New Haven Historic District Commission

Application For CERTIFICATE OF APPROPRIATENESS

ltem i	ADDR	LESS OF	PROPER	ΙY
	119	South	Water	St

Re: 119 South Water Street, Application for Certificate of Appropriateness

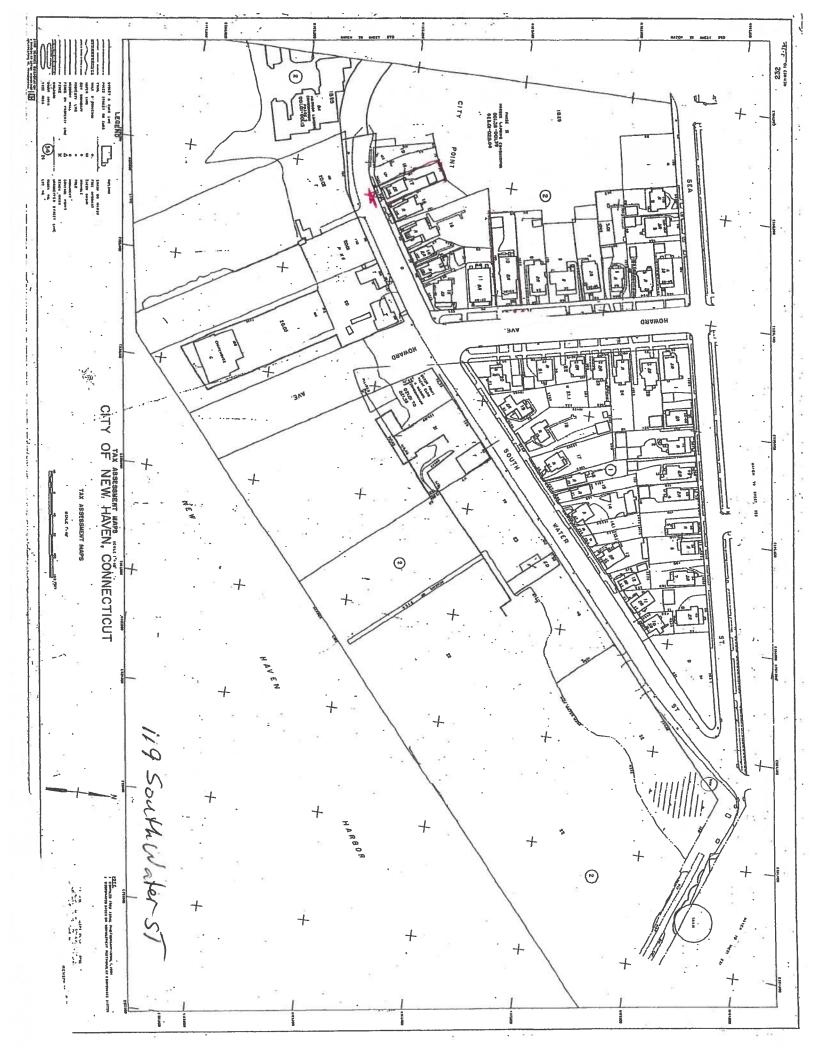
- There are a variety of window types and sizes in the basement: awning, hinged, and double hung. The replacement window cut sheet in the application does not match the size, lite pattern or type of the existing windows. Please explain why.
- Provide labels and a key for the location of all window photos that are taken from inside the house.

- Provide an explanation of why 2 over 2 windows are proposed to replace existing 6 over 6 windows.
- The application includes only one cut sheet for one window type. Provide a cut sheet and specifications for gable windows, and decorative/accent windows.
- The description of the work lists 22 windows at 31"x54" to be replaced, but the cut sheet lists different dimensions for both the opening and frame. Explain how the new windows will fit into an opening with different dimensions. Will new material be added or original material removed?

- a. Per the Description of the Proposed Work, the large front basement window will be two-over-two to match the other windows in the building. The 3 boarded up basement windows will be special made to match the only existing basement window still intact vertical triple pane.
- b. The basement window pictures are labeled as to their locations front double hung; front right side; rear right side; front left side; and rear.

- a. Two-over-two windows are proposed to be consistent with former HDC approvals at 74 Sea St (2019) and 61 South Water St (2020).
- b. I do not have cut sheets for the gable windows. These will be special made. I am not aware of any decorative or accent windows on this property.
- c. The cut sheet is demonstrative of the proposed window type. Once an approval is obtained from HDC, the actual order will be placed.
